BOROUGH OF OCEANPORT PLANNING BOARD

REGULAR MEETING • AGENDA

SEPTEMBER 8, 2026 at 7:00 PM

- 10.2. PB2026-08 Old Wharf Development, LLC
Block 121, Lot 1.01 & 2
298 & 306 East Main Street

BUILDING "B" FRONT ELEVATION

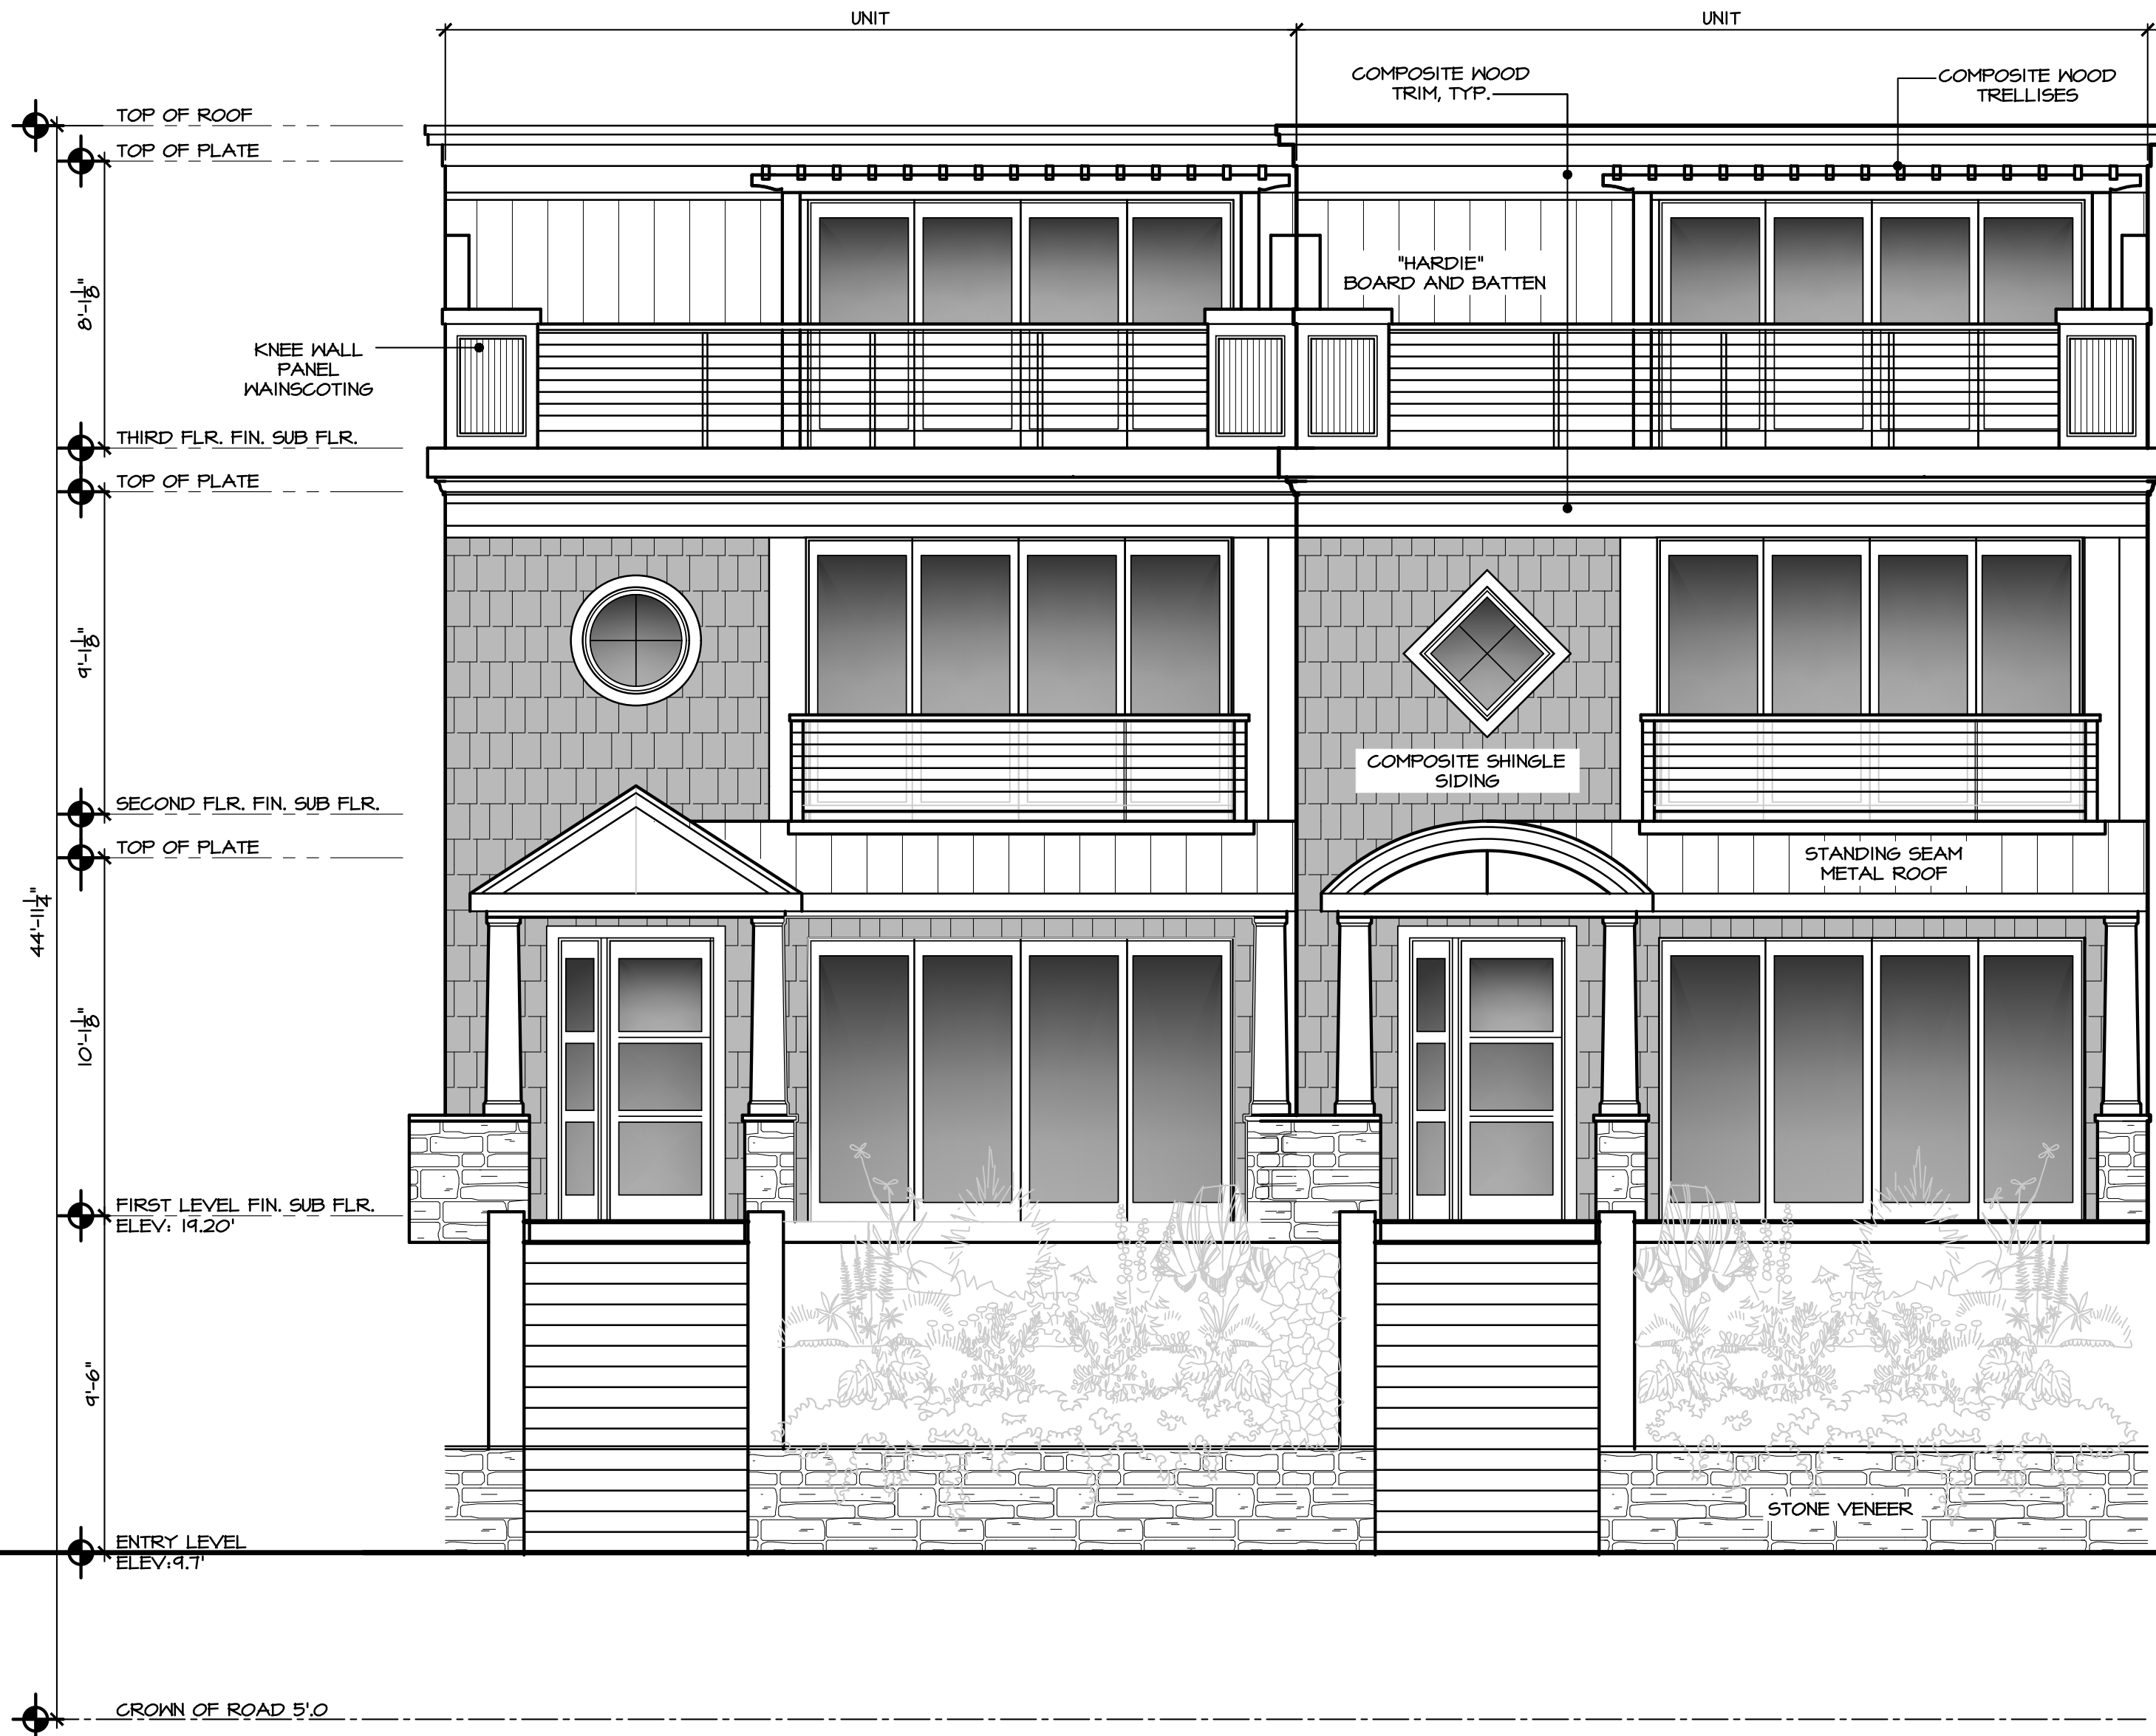
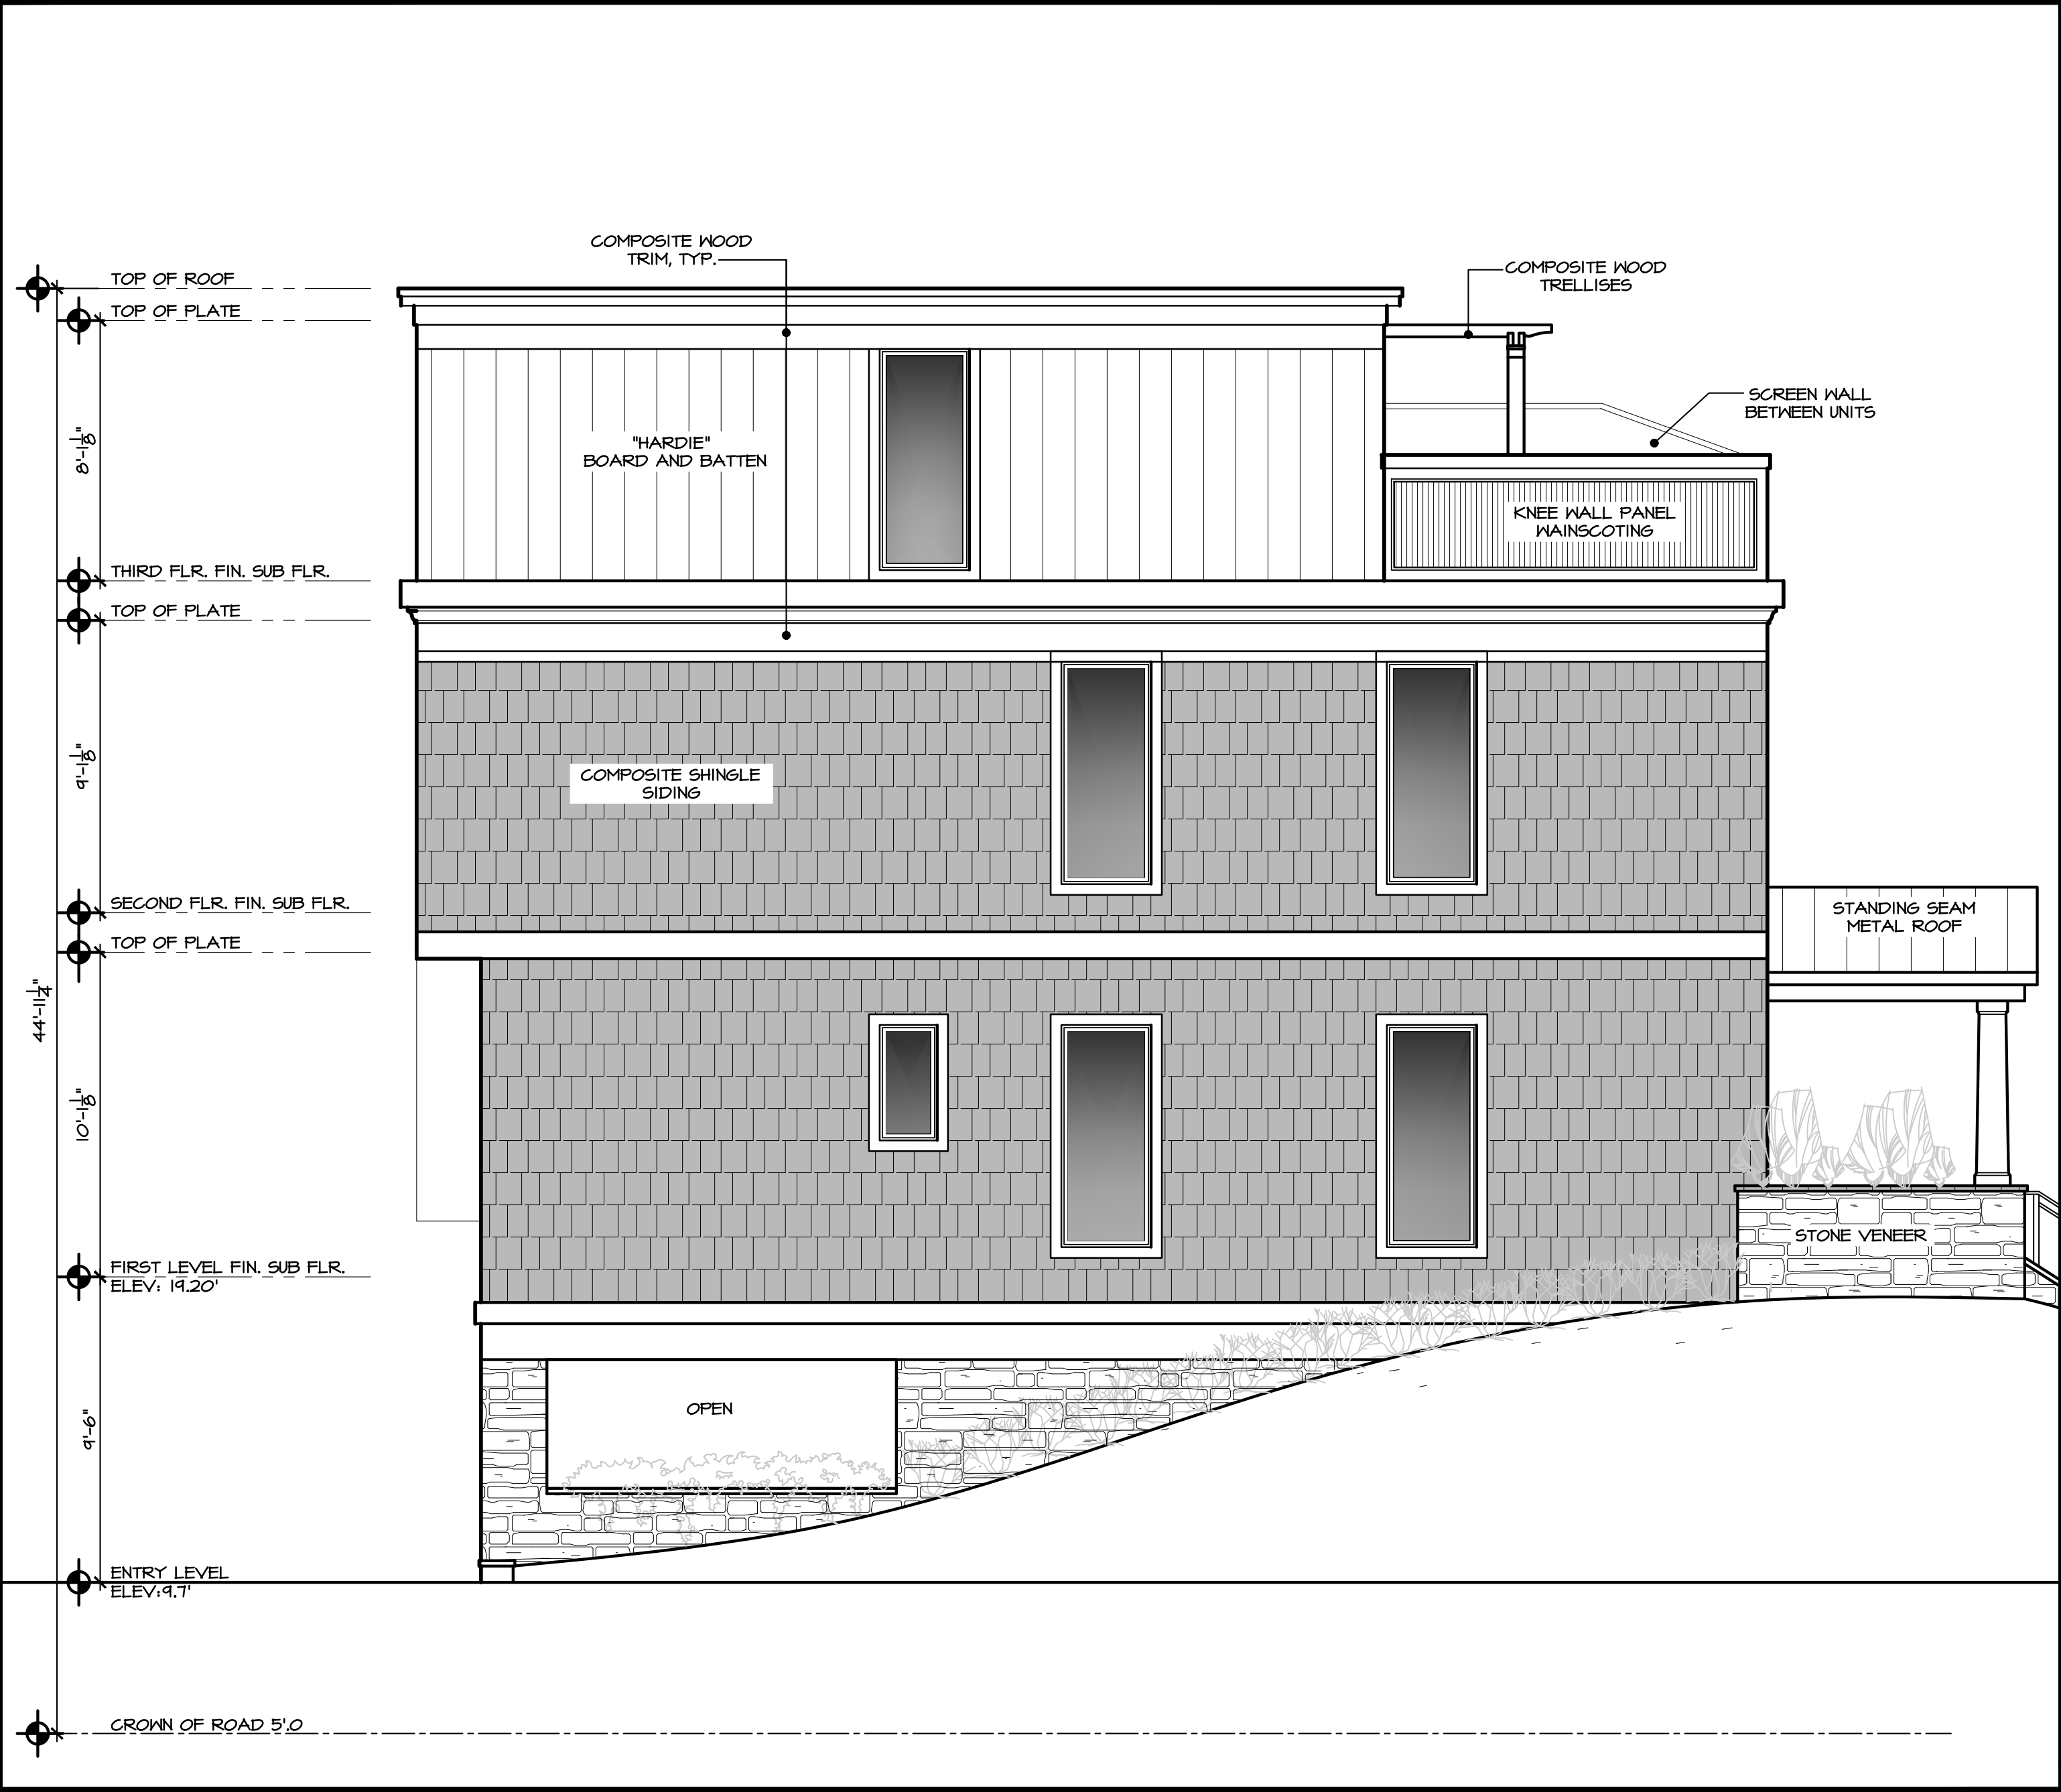
2. Testimony shall be provided as to the height of each building as the Architectural plans indicate that Building B exceeds the permitted height of 45 feet.
3. The parcels are situated within the AE8 Flood Zone. Clarification is required regarding the layout and elevation of the entry level for Building B, as well as the potential need for flood venting.
4. The applicant is requested to confirm whether NJAWC will require a "Hot Box" for the incoming water service. If required, please specify its proposed location.
5. The improvements will disturb portions of the paver sidewalk along East Main Street. These areas and any settled area of the sidewalk shall be reconstructed with matching materials.
6. Structural Designs and computations shall be provided for all retaining walls that are signed and sealed by a New Jersey Professional Engineer.
